Well Name: UMT	Well Location: T31N / R14W / SEC 22 / TR J / NWSE / 36.530803 / -108.175257	County or Parish/State: SAN JUAN / NM
Well Number: 22-D	Type of Well: CONVENTIONAL GAS WELL	Allottee or Tribe Name: UTE MOUNTAIN UTE
Lease Number: 751051025	Unit or CA Name:	Unit or CA Number:
US Well Number: 300453342300X1	Well Status: Producing Oil Well	Operator: EPIC ENERGY LLC

Reclamation  
Plan

Ute Mountain Tribal 22D

## CONDITIONS OF APPROVAL

Ute Mountain Tribal #22D – 30-045-33423  
36.8846664, -108.292717

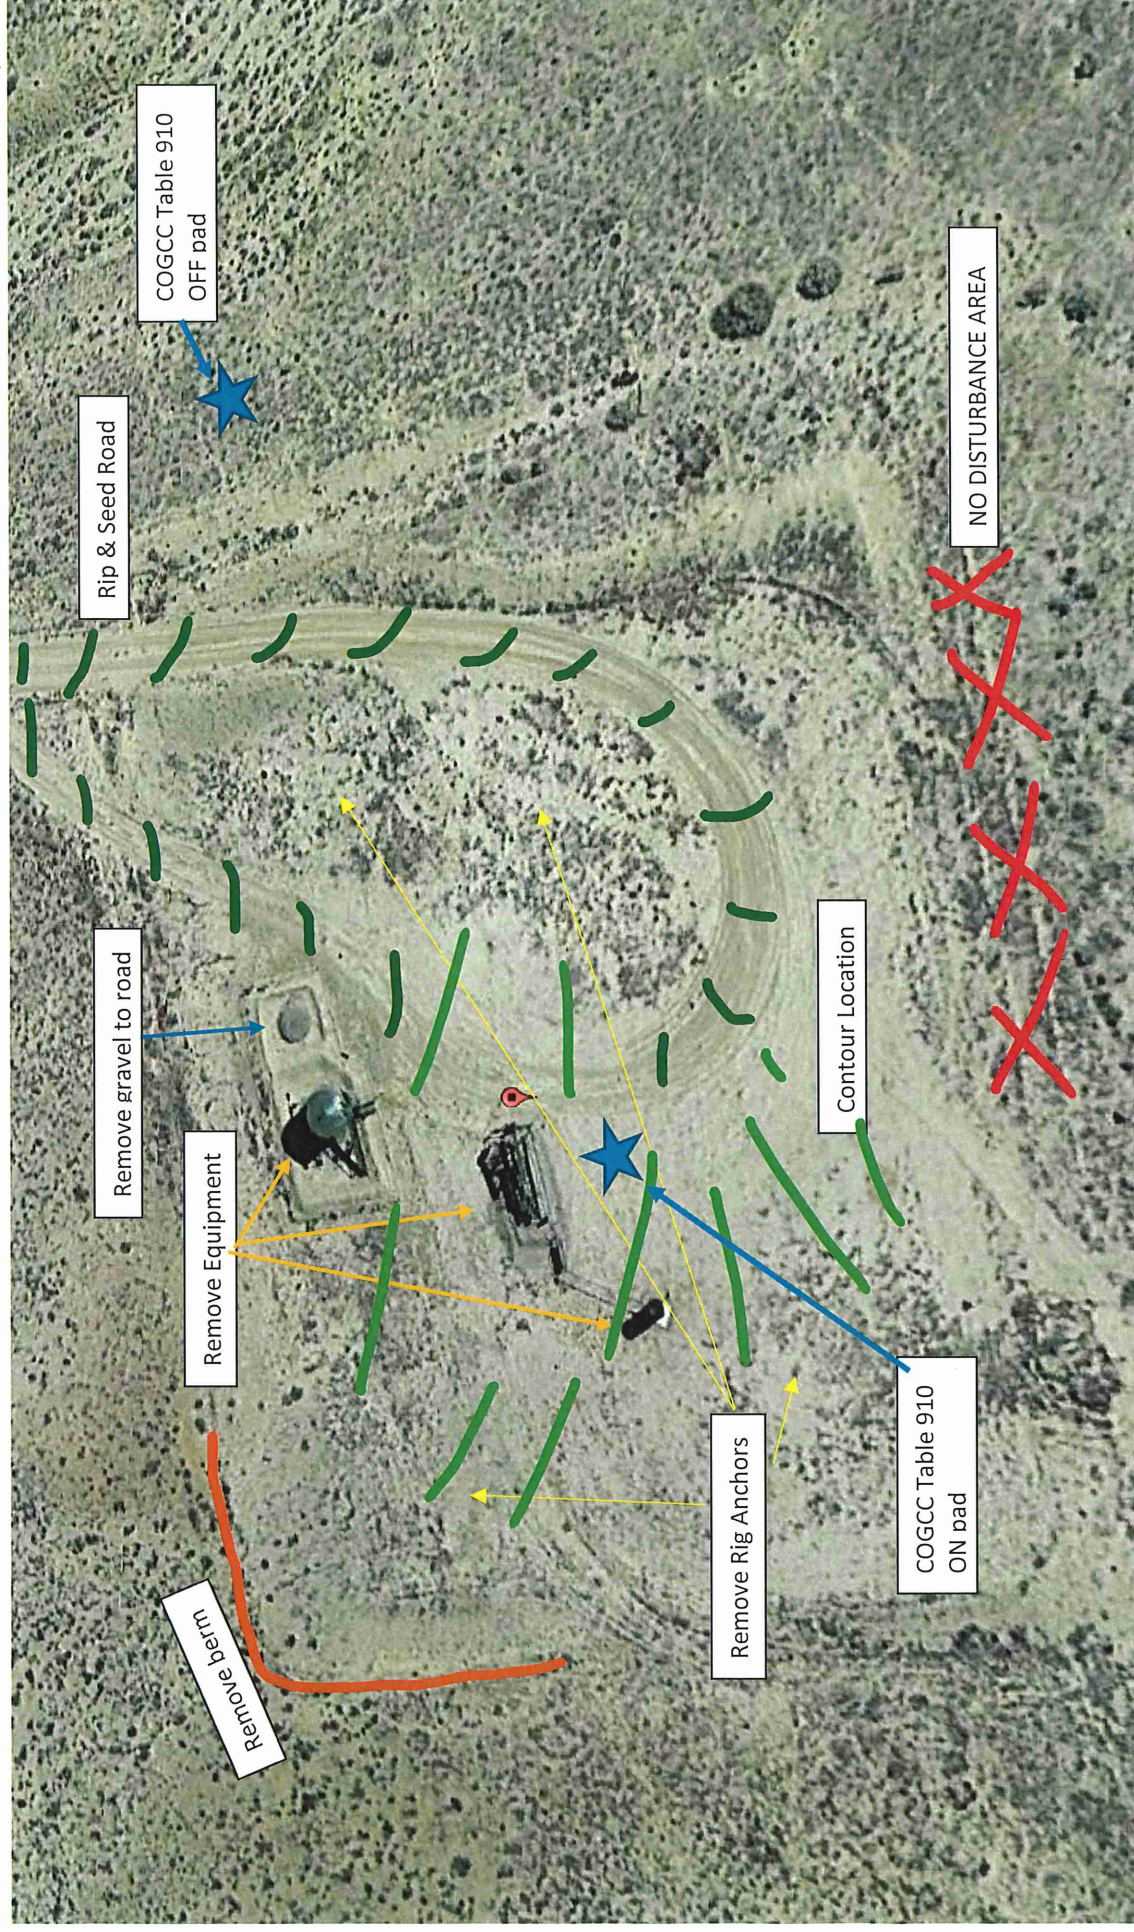
Epic Energy, LLC Test for the full COGCC Table 910 of constituents when all equipment and rig anchors have been removed. Take test from the well pad and off the pad to compare (see map).

- 1 foot out from the well head:
    - i. 6 samples at regular intervals around the well head 1 ft below ground surface
  - 3 feet out from the well head:

- i. 8 samples at regular intervals around the well head 1 ft below ground surface
4. Samples in the secondary containment berm are taken in the follow manner:

6. A background soil sample shall be collected a minimum of 50 feet east of all pad disturbance
7. Global positioning system (GPS) geographic coordinates shall be provided for all soil samples, including the background sample. For composite samples, one GPS point is sufficient, and a diagram of composite aliquots shall be provided with sample result reports.
